## PROJECT NARRATIVE

### RE: PS21-0196 – Substantial Conformance Application – Steamboat Basecamp

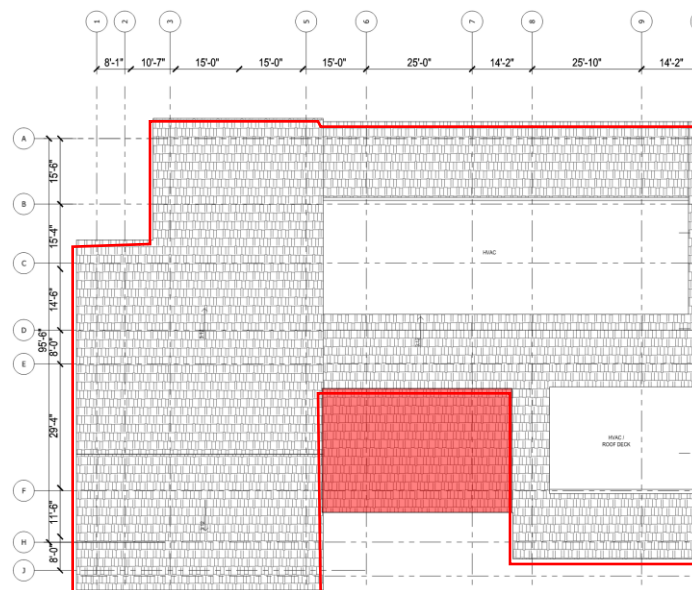
The Applicant is not proposing any modifications to item 2, except for item 2-b. As part of this Substantial Conformance application, the Applicant is proposing to modify the roof area for the small addition to the proposed fitness space, shown in red in the image below (between col line 5-8 and E-F.5). In the approved development plan this roof was sloped at a pitch to generally match the existing roof pitches on either side, however, the design has evolved to now include a flat roof.

- 1) Allows to better accommodate the mechanical equipment (screened per CDC standards) needed for the commercial space in order to avoid having to structurally retrofit the existing mechanical well between column lines B-D/5-9.

- 2) Allows the Applicant to not have to tie into the existing roofing system near column line E, which could prove difficult given its age.
- 3) It solves for the condition at the plan east tie-in location where the new roof would need to perfectly extend the existing slope of the adjacent roof, with little to no construction tolerance, resulting in a visible construction joint(s).

- 4) It presents a clear differentiation of volume, which provides for a clean edge condition. Instead of trying to conceal construction joint lines at the tie-in, the Applicant is able to use this design change as an opportunity to relate the larger 5-story new construction volume to the existing-to-remain portion of the structure, also providing additional variation in form and façade.
